**County of San Diego
Planning & Development Services
BUILDING DIVISION**

ACCESSIBILITY CORRECTION LIST

**Hotel, Motel, and Other
Transient Lodging Uses**

FIGURE 11B-804.2.1
PASS THROUGH KITCHENS

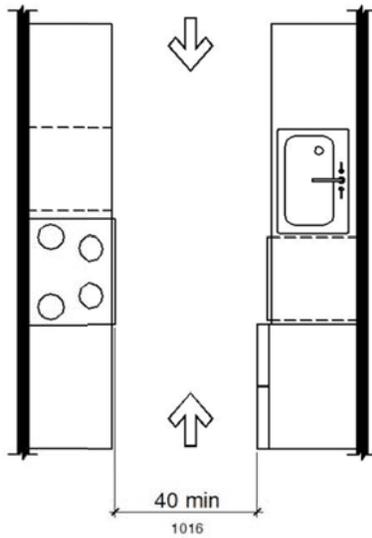
11. Dimension clearances at any kitchens per the following:

- In pass-through kitchens – i.e., minimum two entries – per CBC Figure 11B-804.2.1
- U-shaped kitchens per CBC Figure 11B-804.2.2
